**SUBDIVISION, PLANNING APPROVAL  
PLANNED UNIT DEVELOPMENT  
& SIDEWALK WAIVER STAFF REPORT**

**Date: December 4, 2008**

| <b><u>DEVELOPMENT NAME</u></b>              | 1551 Cochrane Causeway  |
| <b><u>SUBDIVISION NAME</u></b>              | Chippewa Lakes Blakely Island Subdivision   |

## SITE PLAN

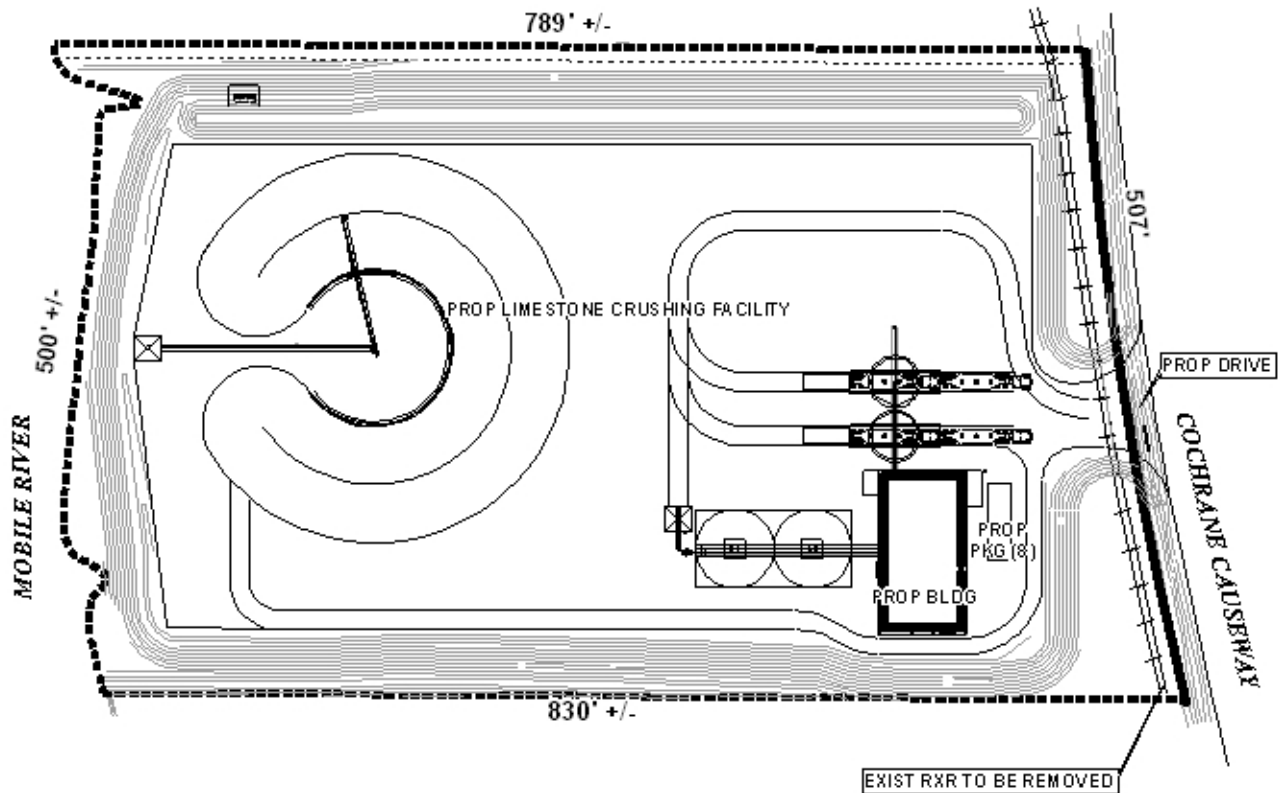
The preliminary plat illustrates a 30-foot AT & N Railroad right-of-way and a 25-foot minimum building setback is illustrated as well. As illustrated on the preliminary plat the 25-foot minimum building setback cannot be within the 30-foot AT & N railroad right-of-way; therefore, either the vacation of this right-of-way or the placement of the 25-foot minimum building setback to start at the end of the 30-foot AT & N railroad right-of-way.

As indicated on the site plan, access to this facility is to be via a new drive to Cochrane Causeway, a major street with existing right-of-way of 120' at this location. As Cochrane Causeway is a major street, access management is a concern. Access management is a concern due to the site fronting on a major street; therefore, the development should be limited to one curb cut to Cochrane Causeway, with the size, design and location of all curb-cuts to be approved by Traffic Engineering and conform to AASHTO standards.

- 1) placement of a note on the final plat stating that the development is limited to the one curb cut along Cochrane Causeway, with the size, design and location to be approved by Traffic Engineering and conform with AASHTO standards;
- 2) the vacation of the AT & N Railroad right-of-way prior to the signing of the Final Plat, or the illustration of the 25-foot minimum building setback to be relocated behind the 30-foot railroad right-of-way;
- 3) the labeling of the lot with its size in square feet, or placement of a table on the plat with the same information;
- 4) placement of a note on the Final Plat stating that the maintenance of the detention common area is the responsibility of the property owners; and
- 5) full compliance with all other municipal codes and ordinances.

## SIDEWALK CROSS SECTION DETAIL

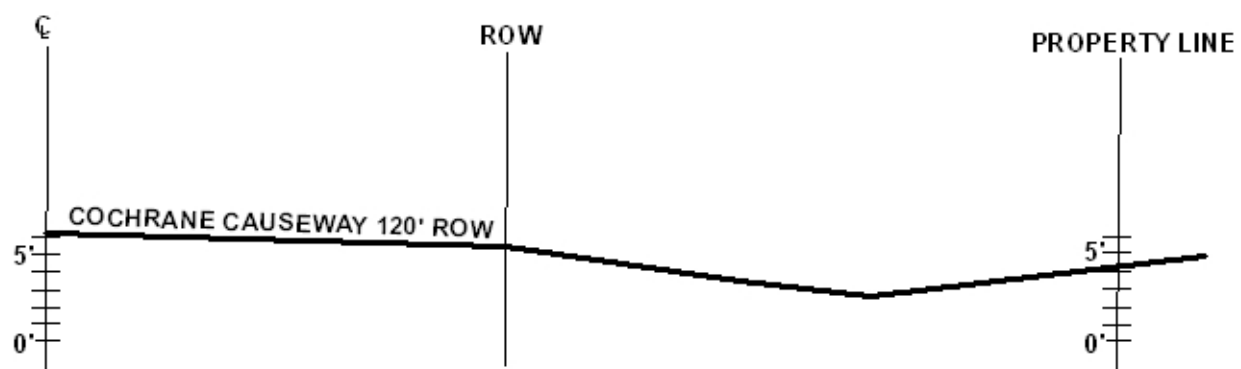
| <b><u>ENGINEERING COMMENTS</u></b>          | Based on the flood study that was conducted, a LOMR will be required following construction of the site. Recommend approval of sidewalk waiver due to conflicts with drainage.  |

With regard to the Sidewalk Waiver Request, the applicant contends that the sidewalk should be waived because there are no existing sidewalks present along Cochrane Causeway and no room between the edge of pavement and the ditch to construct a sidewalk to city standards.

The applicant is correct in that there are no existing sidewalks in this area. However, the Commission has rarely allowed the absence of sidewalks in an area as justification for the granting of a sidewalk waiver. The provision of a sidewalk in that area would seem more desirable than pedestrians walking along this section of Cochrane Causeway with no sidewalk or defined or delineated walking path.

**Sidewalk Waiver:** Based upon the preceding, this application for waiver of the sidewalk along Cochrane Causeway should be approved.
